Addendum / Addenda

Project Description / Description de projet M38 M38 Electrical Service		
Solicitation No./N° de sollicitation 17-22113	Project No./N° de projet 5310	W.O. No./N° d'ordre de travail A1-006442-01
Departmental Representative / représentant ministériel Allan Smith		Date January 15, 2018
Notice: This addendum shall form part of the tender documents and all conditions shall apply and be read in conjunction with the original plans and specifications.		Nota: Cet addenda fait partie intégrale des dossiers d'appel; toutes les conditions énoncées doivent être lues et appliquées en conjonction avec les plans et les devis originaux.

- 1 Included with this addendum are replacement drawings 5310-E01R, 5310-E02R, 5310-E03R to replace 5310-E01, 5310-E02 and 5310-E03.
- 2 A question was raised regarding the size of the transformer secondary wiring. It is to be 3 x (4 #350+GND RWU90). Cable spec as below:

project **BUILDING M-38** projet
ACOUSTICAL FACILITY
 1200 MONTREAL ROAD CAMPUS
 OTTAWA, ON
 drawing **M-38 SINGLE LINE DIAGRAM AND PARTIAL** dessin
FLOOR PLAN

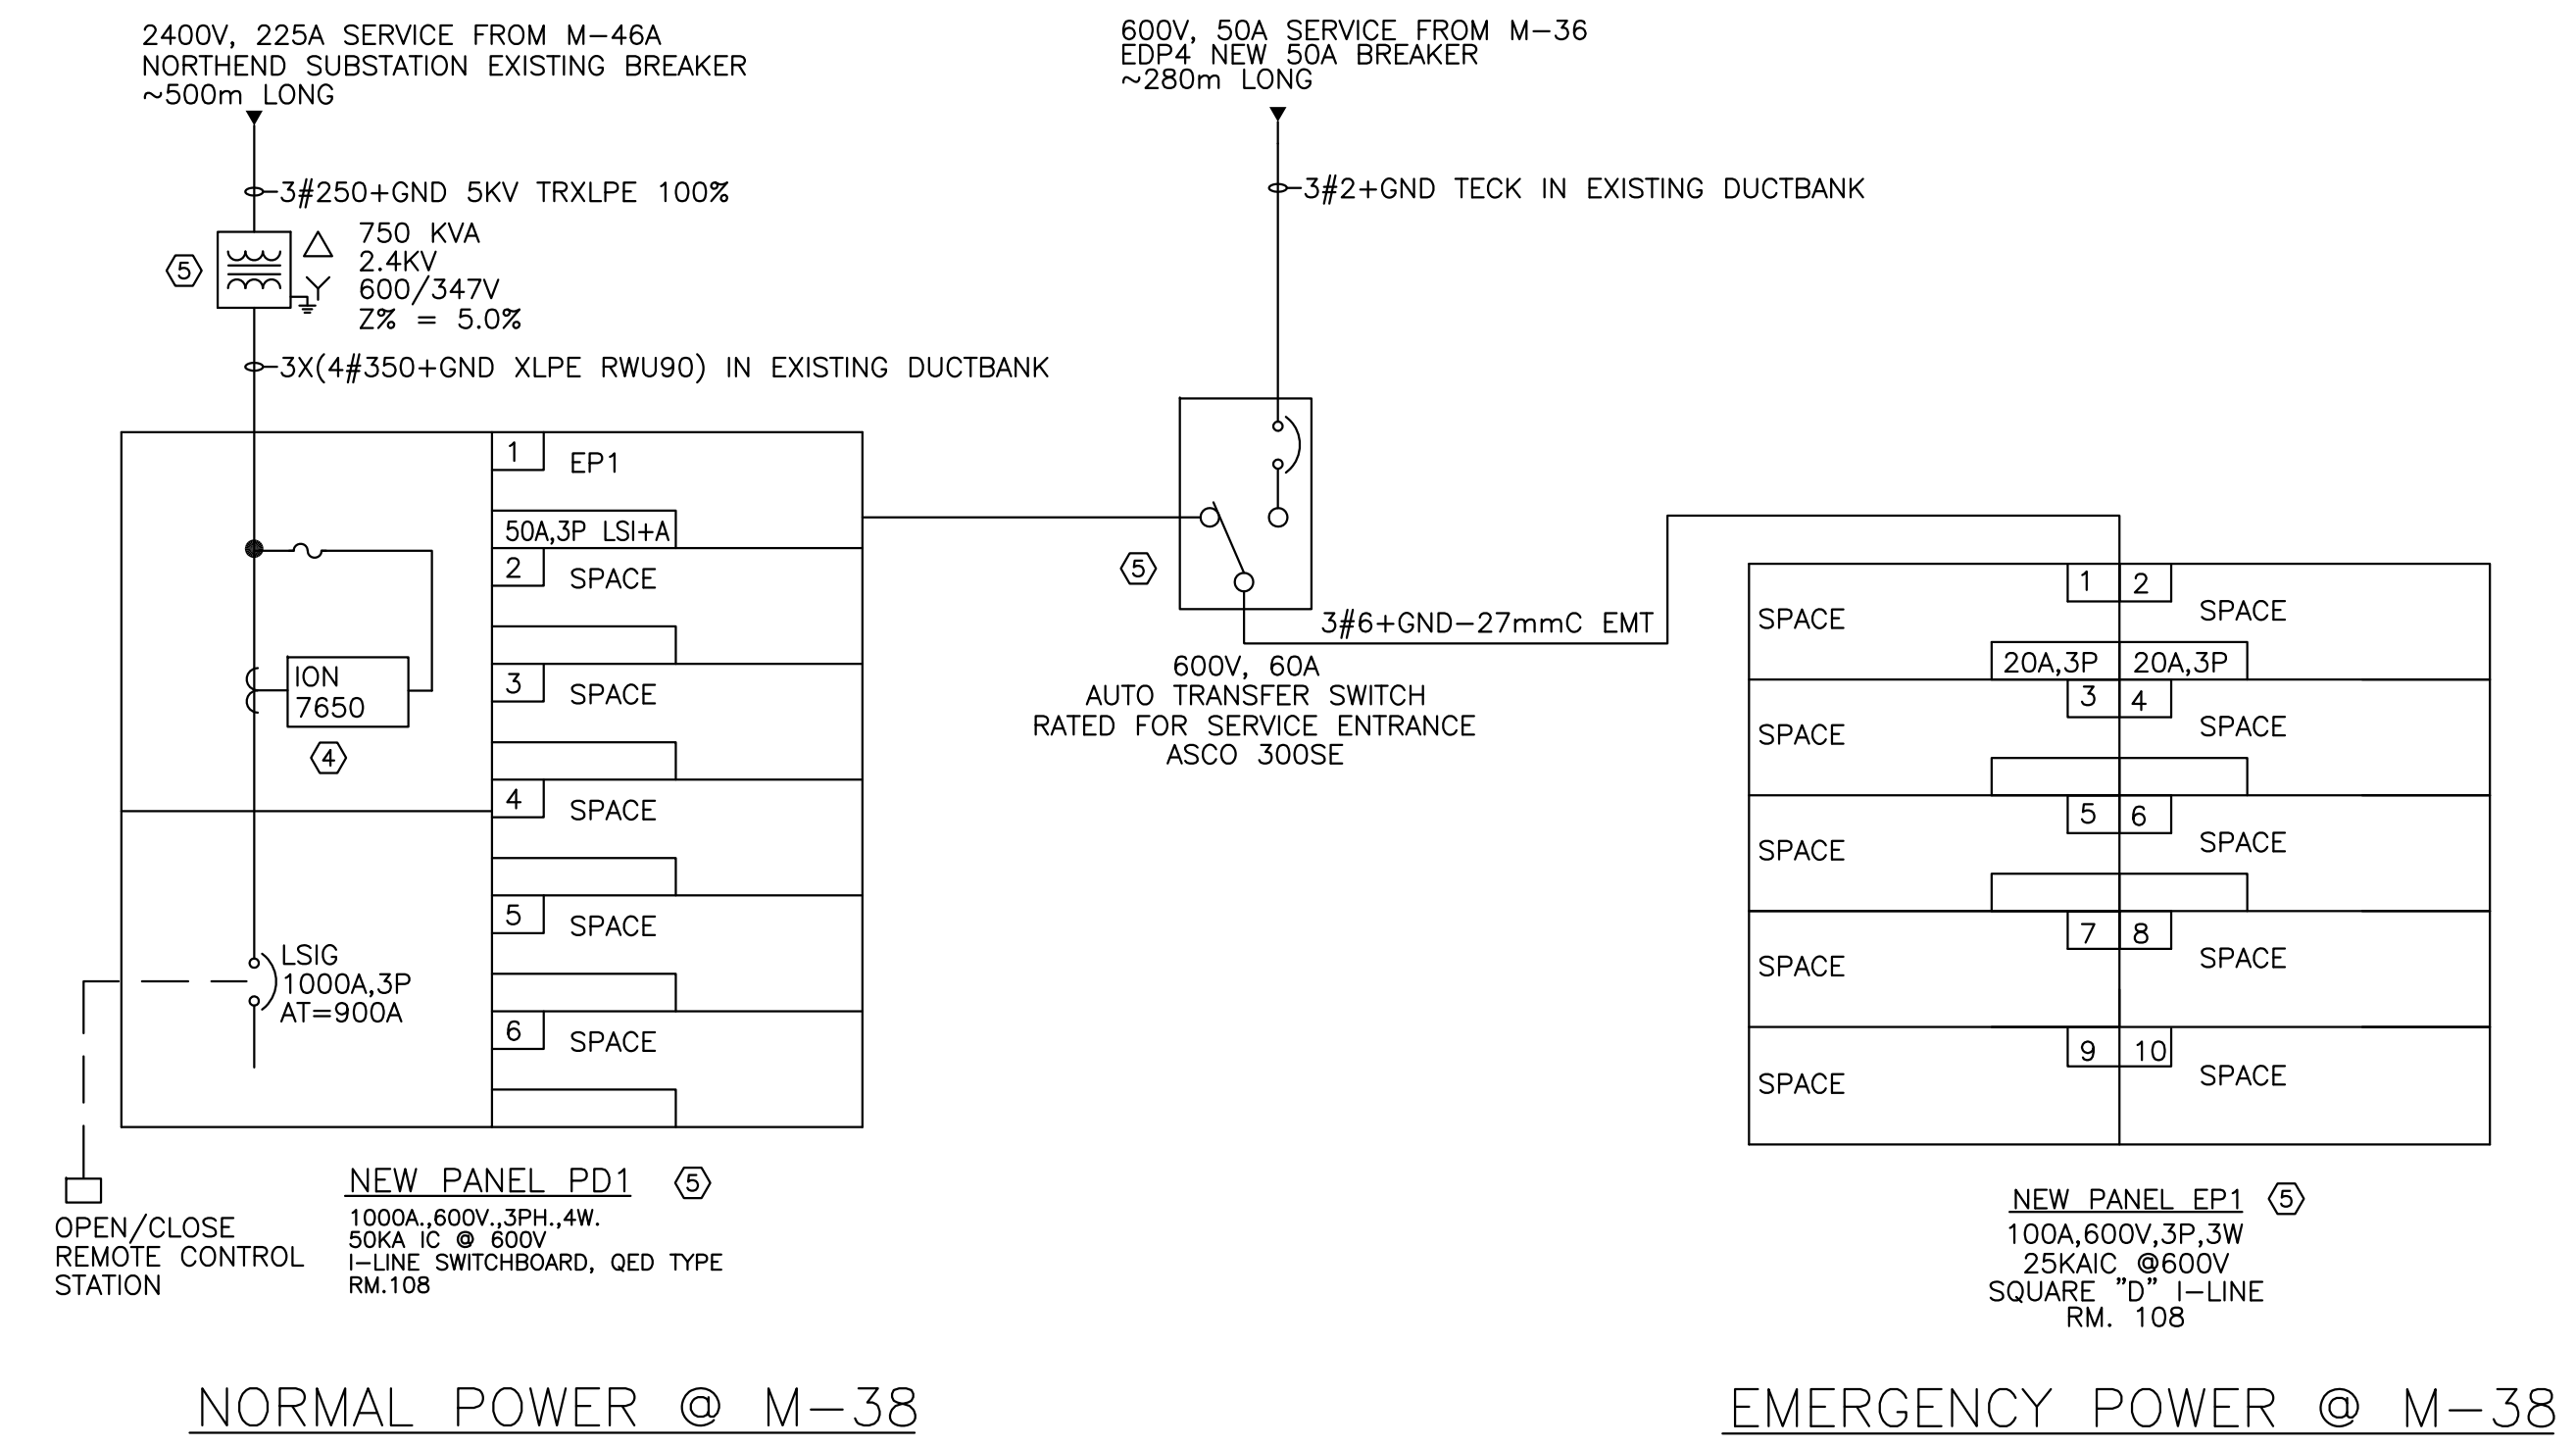
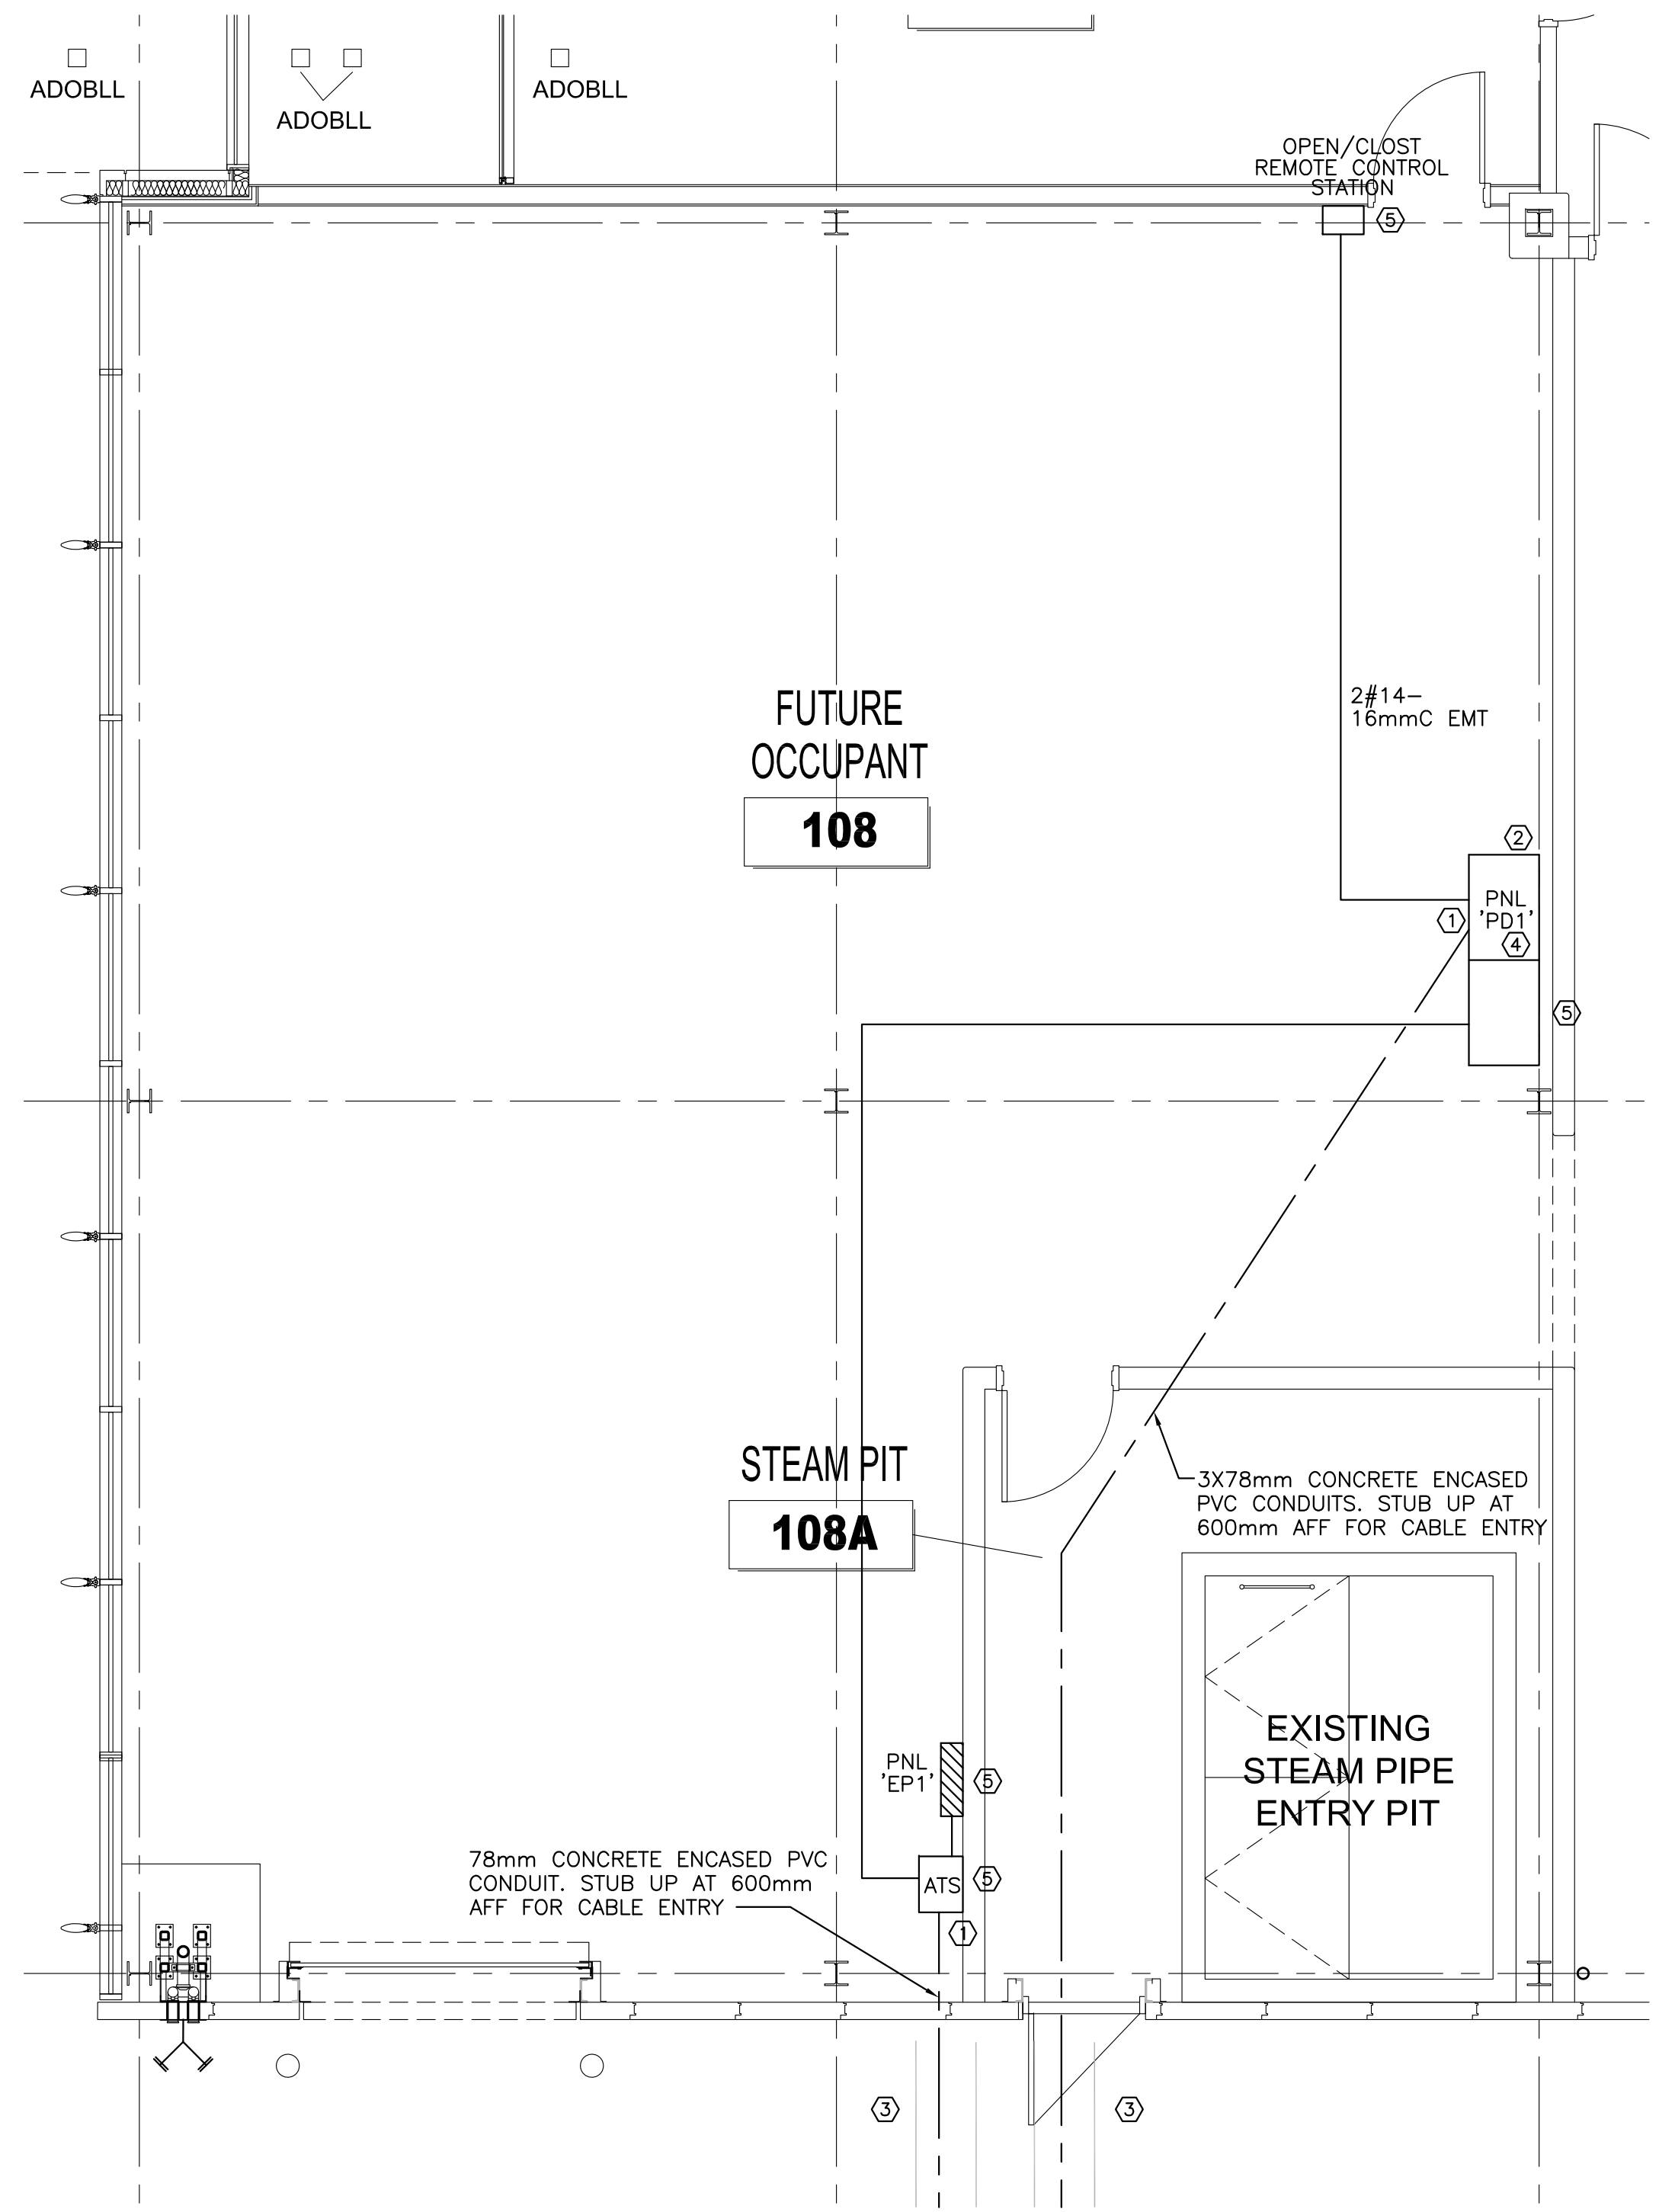
- 6 Panel 'PD1' main 1000A breaker to be LSIG type c/w Ground Fault, Power meter, and PadLock Attachment-fixed.
- 7 750KVa dry type transformer to be rated for pad-mounting without fencing around. The transformer must be certified to CAN/CSA C22.2 No.47-M90 (Air Cooled Distribution Transformer (Dry Type) up to 46KV) and CAN/CSA C227.4 (Three Phase Tamper Resistant Pad Mount Transformer (Up to 27.6KV)(Up to 2500 KVA)).

- 9 Trenching and backfilling within M-38 for the PD1 and EPD1 feeds will be completed by M. Sullivan & Son. Coordinate work with them.
- 10 Routing of cabling within M-36 can be done during normal working hours. Work is to be coordinated through the NRC Departmental Representative and timing of work may be restricted based on operational needs of the building occupants.
